SUNDRY NOTICES AND REPORTS ON WELLS

8. Well Name and No.
Tank 1 Federal #1

Tank Federal 1
30-025-29888
Matador Production Company
February 12, 2016
Conditions of Approval

Permanent Abandonment of Production Zone Conditions of Approval

Proposed Wellbore

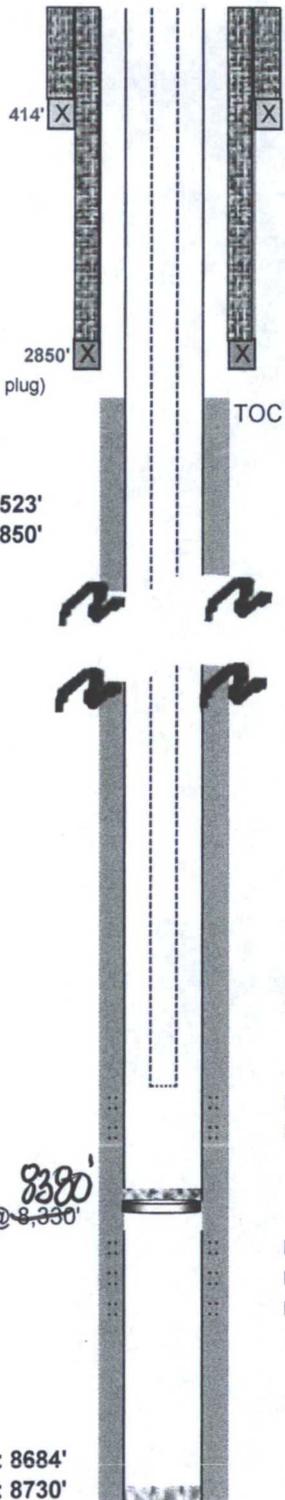
MIRU PU and POOH w/ production tbg, pump & rods
MIRU WL and RIH to set CIBP @ ± 8,380'. Dump 35' CMT on CIBP. Load and test casing to 500#
RIH and perf 1st Bone Spring Sand from 7,988'-7,998' and 8,086'-8,094'.
RIH w/ tubing and packer, set pkr @ ± 7,900'
Acidize perfs @ 7,988'-7,998' and 8,086'-8,094'.
Swab test
Frac perfs @ 7,988'-7,998' and 8,086'-8,094'.
POOH w/ pkr, RIH w/ production tbg, pump & rods. Put well on Production

- 1. Operator shall place CIBP at 8,380' (50'-100' above top most perf) and place 35' of Class H cement on top. WOC and tag.**
- 2. Must conduct a casing integrity test before perforating and fracturing. Submit results to BLM. The CIT is to be performed on the production casing to max treating pressure. Notify BLM if test fails**
